Summary of DP11626 (Abbott et al.): This paper presents an overview of the calibration process and its accuracy in the Advanced LIGO detectors during the time of the GW150914 discovery. It is aimed at interferometry experts (this reviewer is not one), so aspects were difficult to understand without appropriate background.

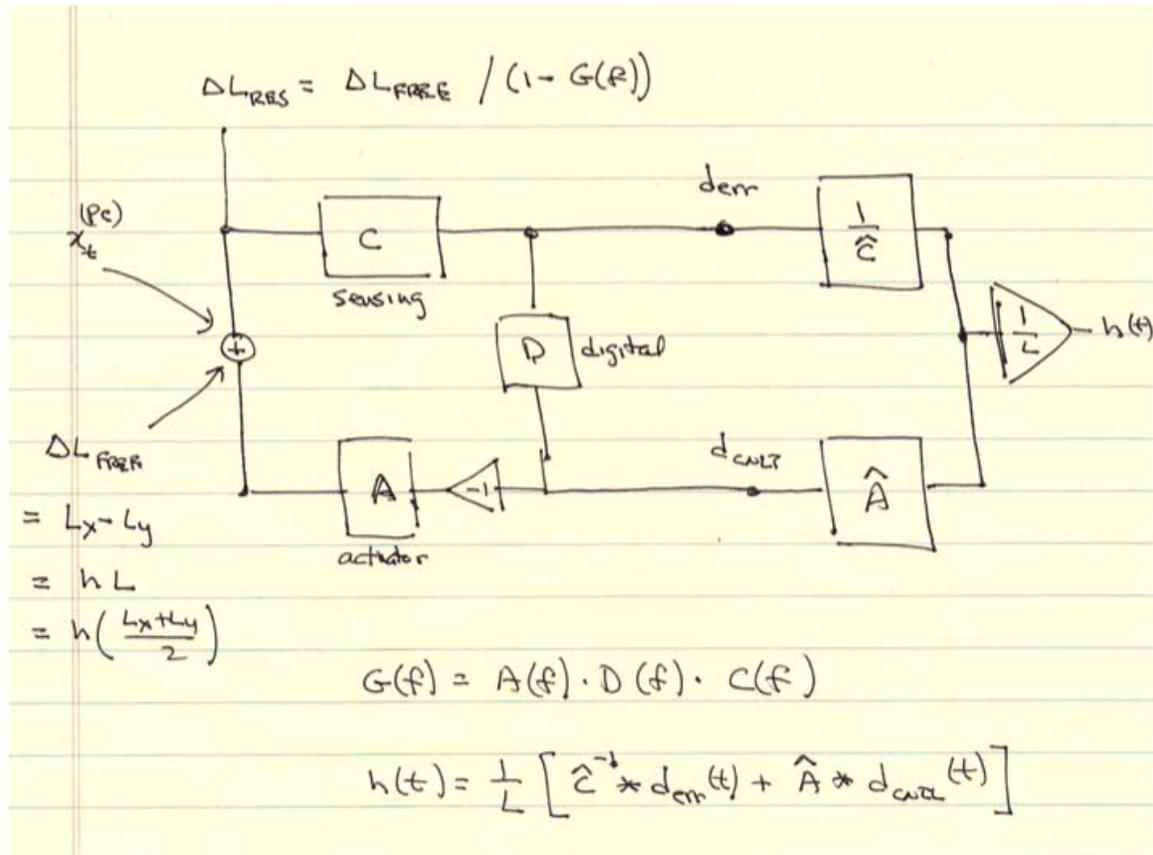
- Figure 2 is essential to understanding the paper. It would be good if the definitions of the quantities in the text could also be on the figure. E.g.:

This would have saved me, e.g., from going back and forth from the text to the figure when I was trying to understand the overview.

- Figure 2: in the caption it would be useful to comment on $x_t^{(PC)}$ other than to say "see Section IV". Something simple like " $x_t^{(PC)}$ is the modulated displacement of the test masses accomplished by the photon calibration apparatus (see Section IV).", for example.
- page 6, below equation 3: Why are the pole frequencies of H1 and L1 (341 and 358 Hz) different? Was this an intentional design decision?
- page 8, near equation (8): is there any evidence for non-Gaussian errors when in the locked condition? Or are these absorbed in the time-dependence of the slowly-varying systematics of the calibration?
- page 8 below equation (9) and the captions of Figures 5 and 6: "data ... are...".
